# Why the Half-Duplex MAC Doesn't Work for P2MP (And what to do about it!)

Ben Brown  
Eric Lynskey  
Glen Kramer  
Hidekazu Miyoshi

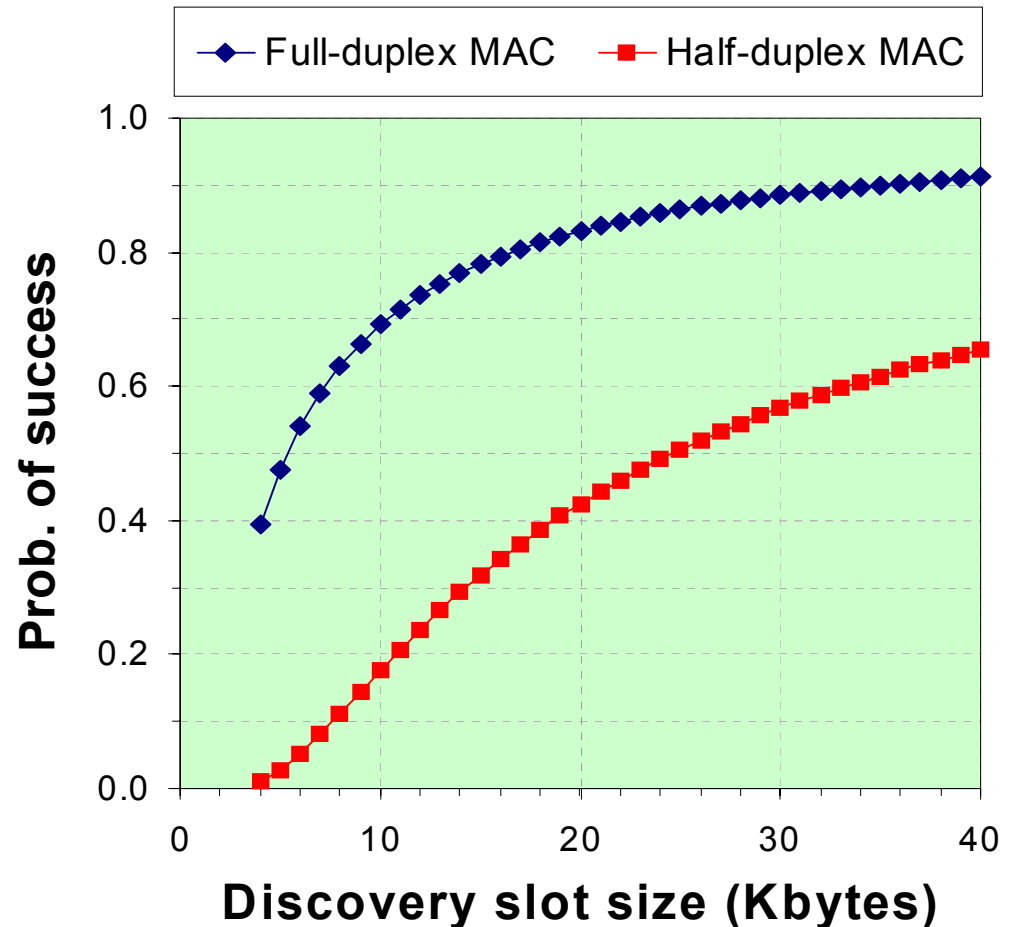
- Half-duplex MAC uses carrier extension
- Shorter frames are extended to minimum size of 512 octets (clause 4.2.3.4)
- Detrimental impact on efficiency

Worst-case (only 64-byte packets)	Empirical packet size distribution
Carrier extension overhead	84%	31.6%
Overall EPON efficiency	10.2%	55.6%

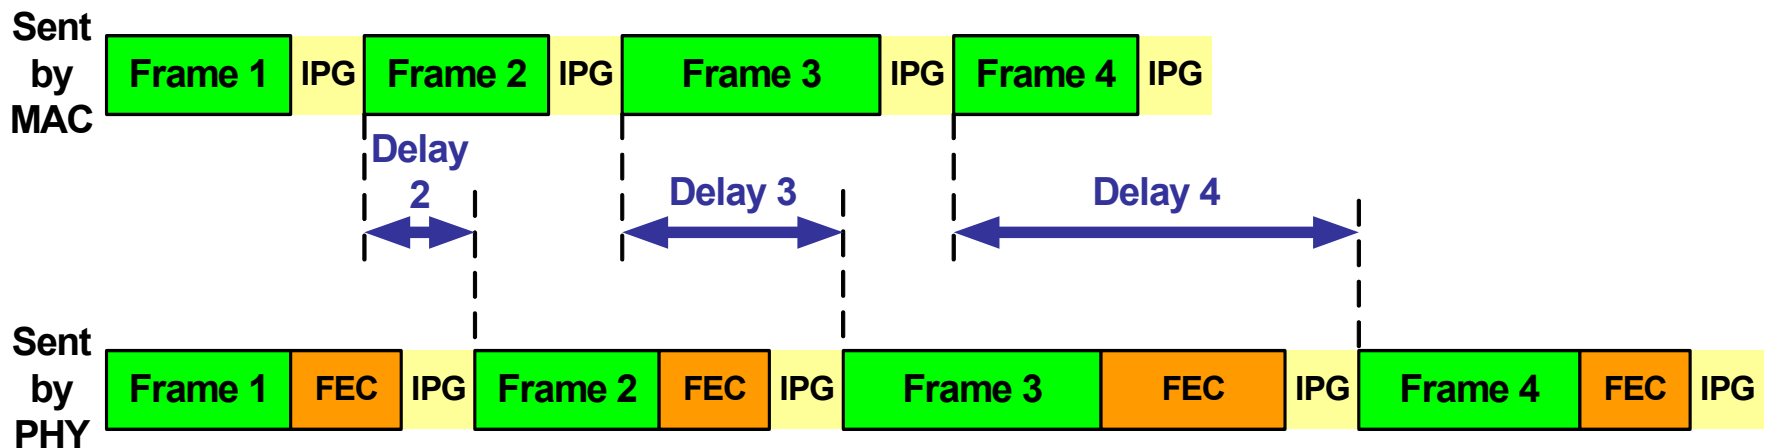
- ONU transmits entire grant as one burst (up to 8k octets). Only the first frame in a burst is extended, if needed.
- Bursting improves upstream efficiency:

Worst-case (only 64-byte packets)	Empirical packet size distribution
Carrier extension overhead	11.3%	6.3%
Overall EPON efficiency	63.5%	85.2%

OLT Control Multiplexer state diagram (Figure 64-11)

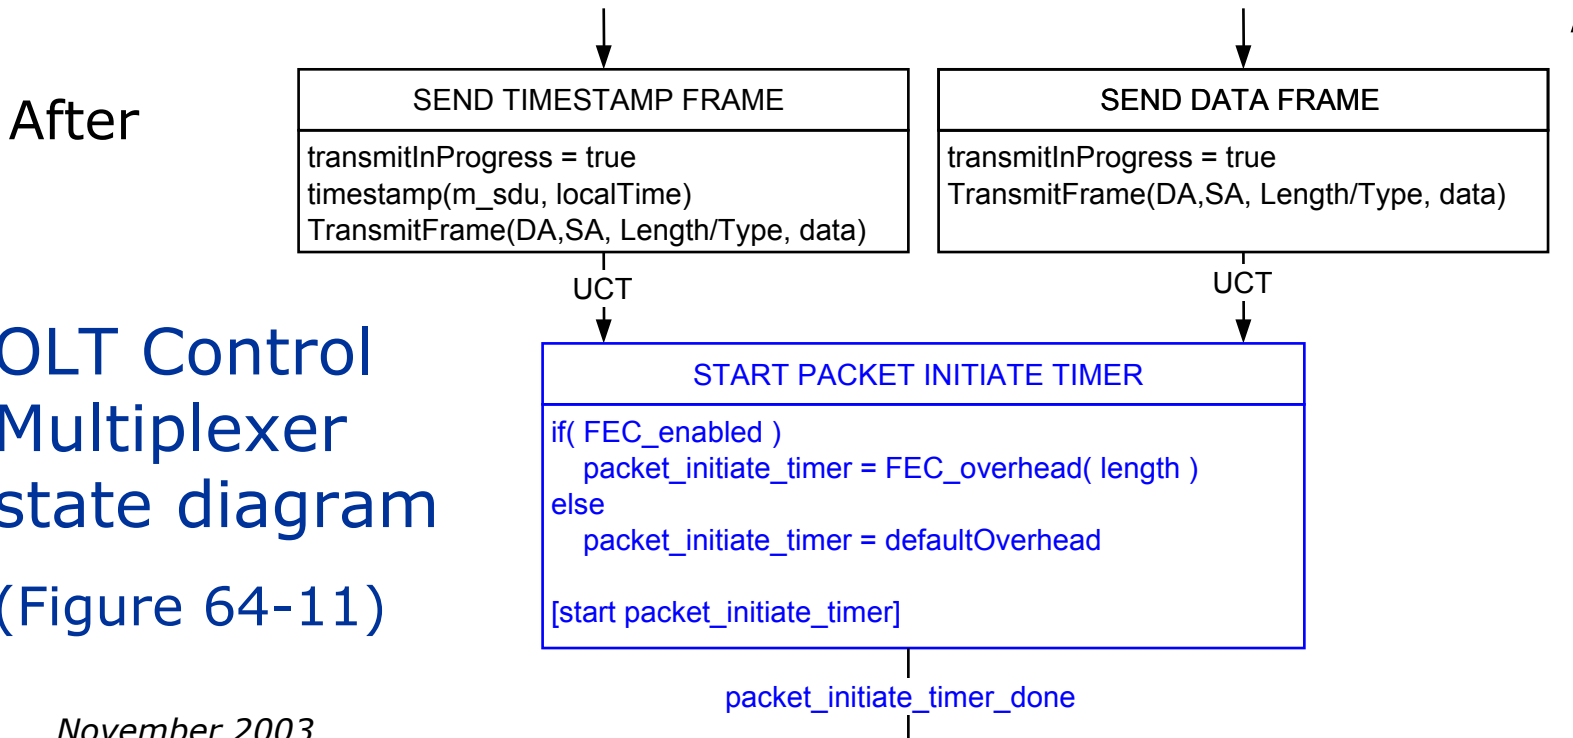
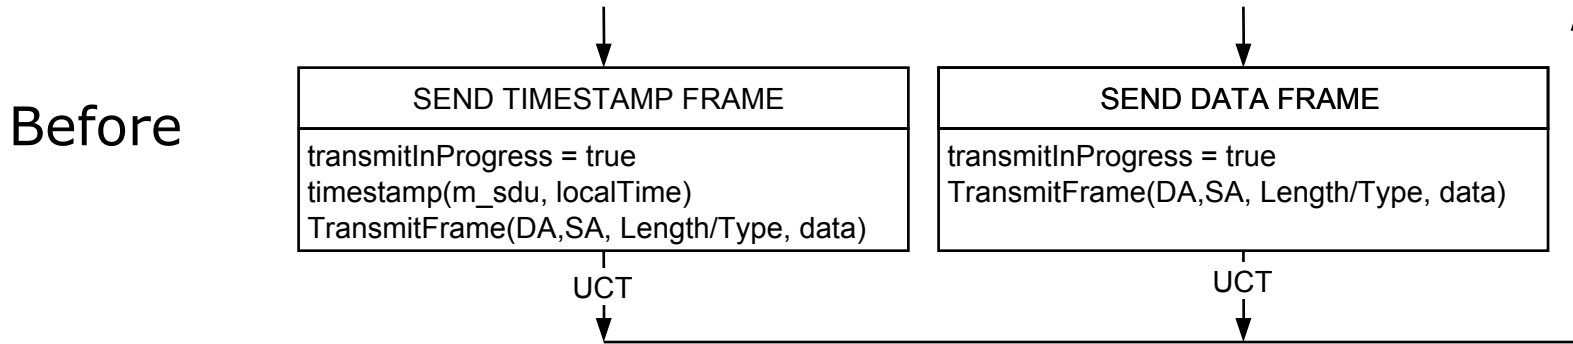
- Only MPCP has a top view of all the logical links, therefore, only MPCP can properly time packet transmissions.
- Multi-Point MAC Control times packet starts
  - Ensures appropriate operation and efficiency
  - Lower layers create IPG exactly as they would with intermittent traffic on any full duplex link
- Removes throughput inefficiencies
- Removes discovery inefficiencies
- Compatible with frame-based FEC
